FEDERAL COMMUNICATIONS COMMISSION

Re: Star Over Orlando, Inc.
WRSO(AM), Orlovista, FL
Facility Identification Number: 129548
File Number: BP-20130429ACX

This letter refers to the above-captioned application for a minor modification of AM broadcast station WRSO(AM) to increase powers.

LAMBERT EQUAL AREA MAP

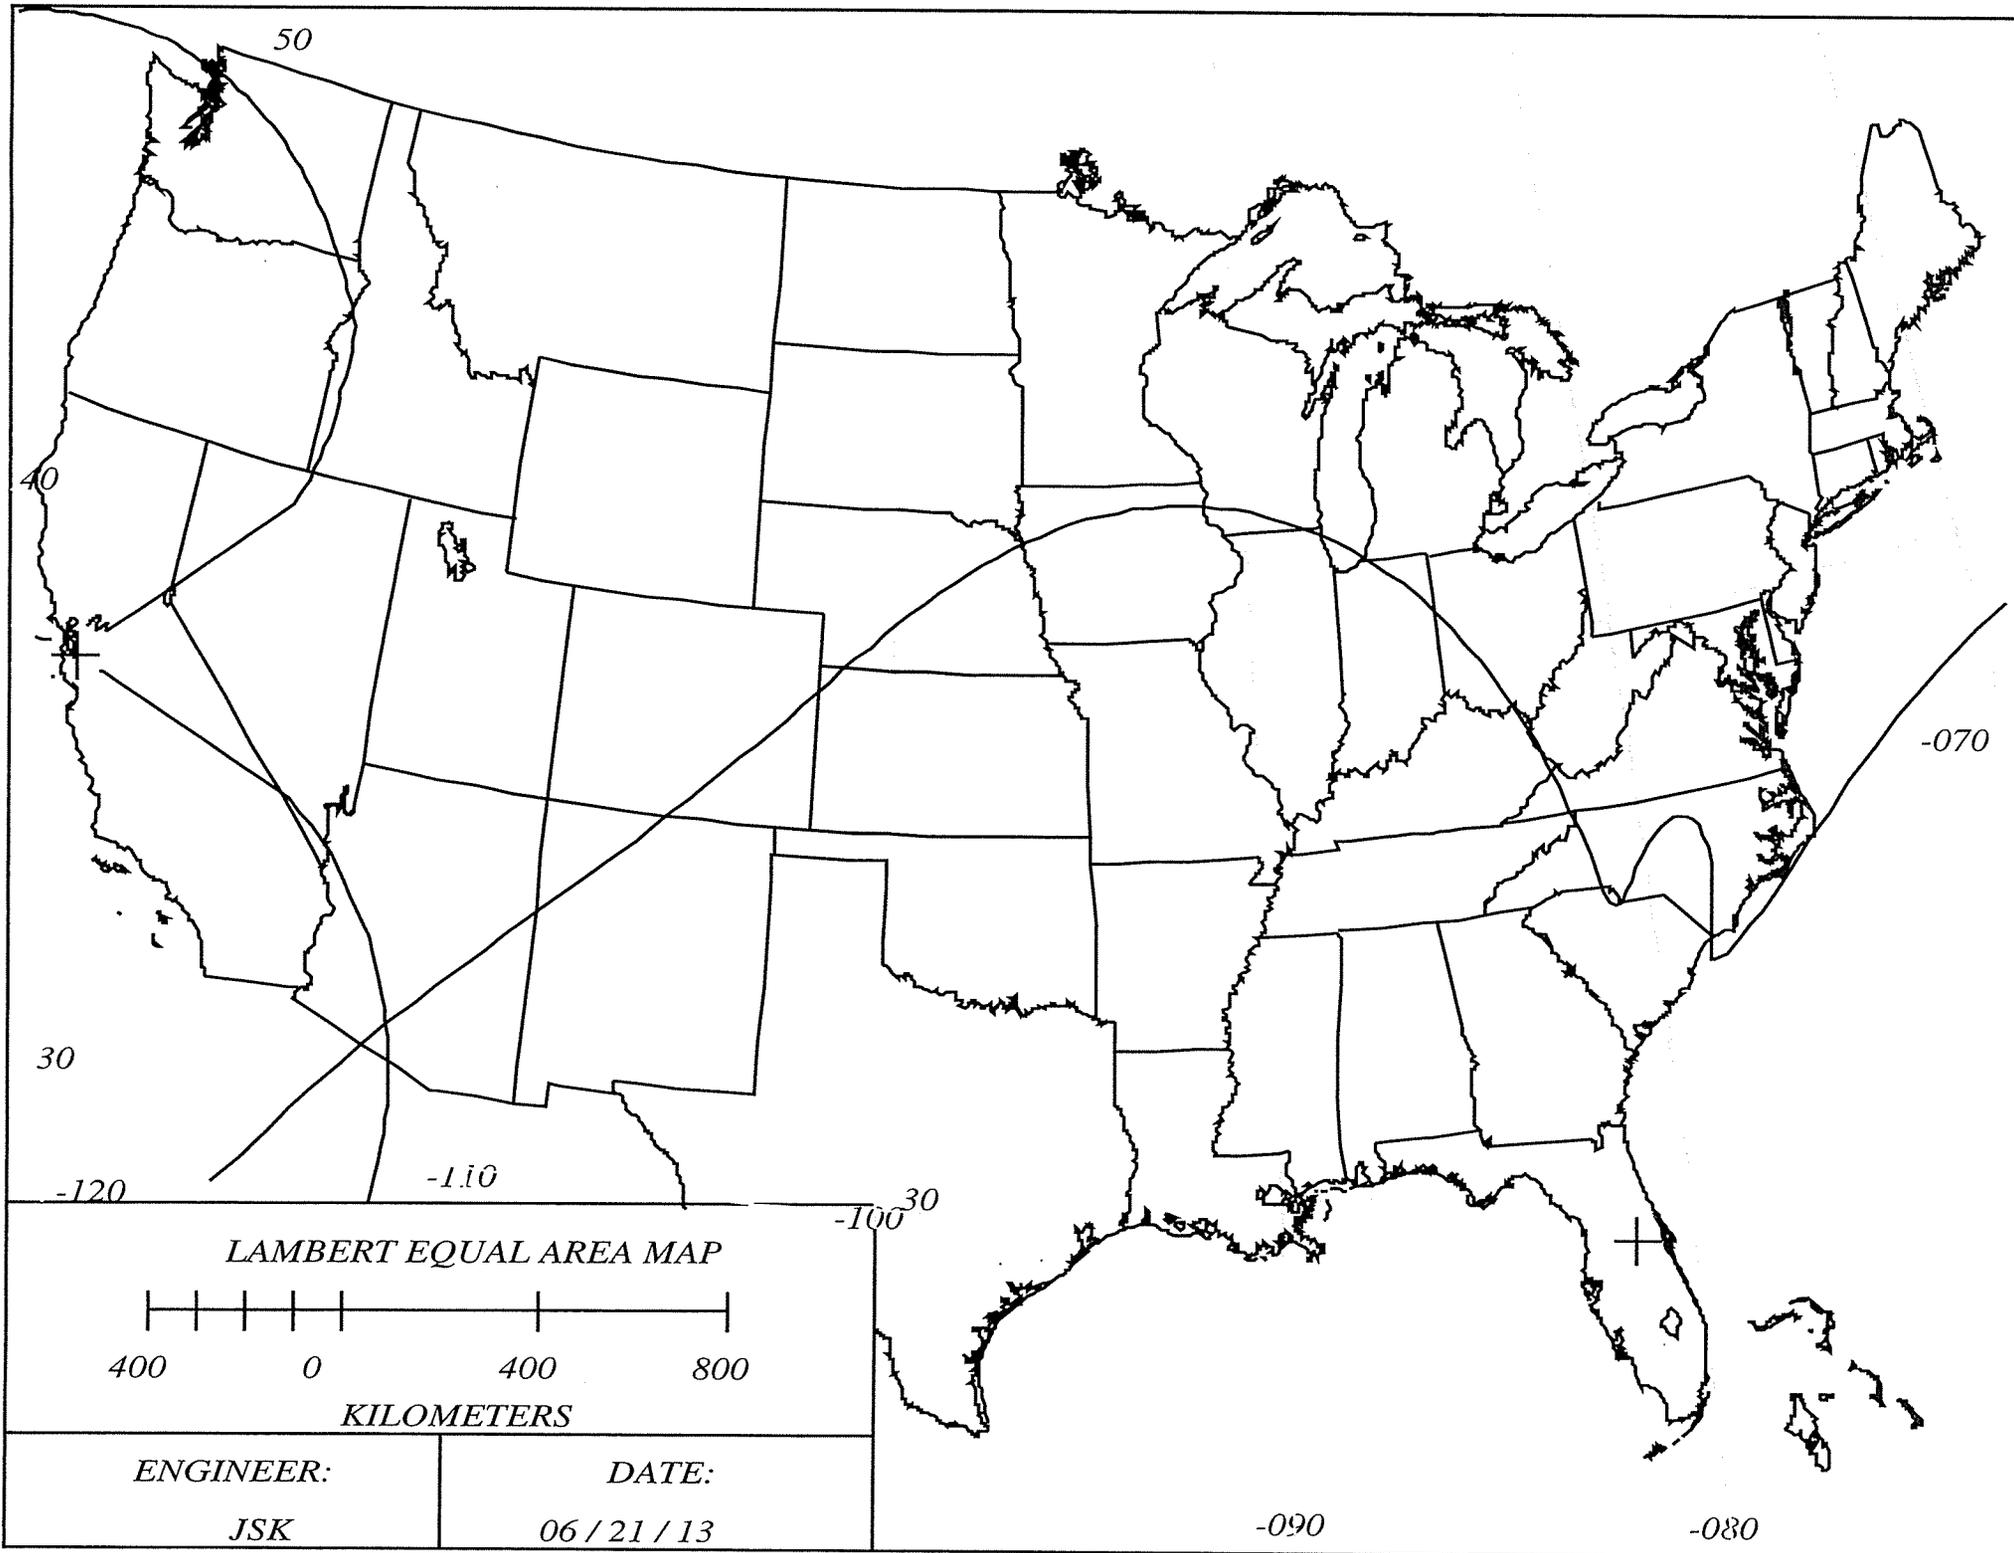
A preliminary engineering review of the application, as amended, reveals that the proposed nighttime 0.025 mV/m-10% skywave contour will overlap the 0.5 mV/m-50% skywave contour of co-channel Class A station KGO(AM), San Francisco, California, in violation of 47 CFR Section 73.182 of the Commission's rules. (See attached exhibit).

Accordingly, further action on the subject application will be withheld for a period of thirty (30) days from the date of this letter to provide you an opportunity to submit an amendment. Failure to amend or respond within this time period will result in the dismissal of the application pursuant to Section 73.3568. Please note that any amendment must be submitted in the same manner as the original application.
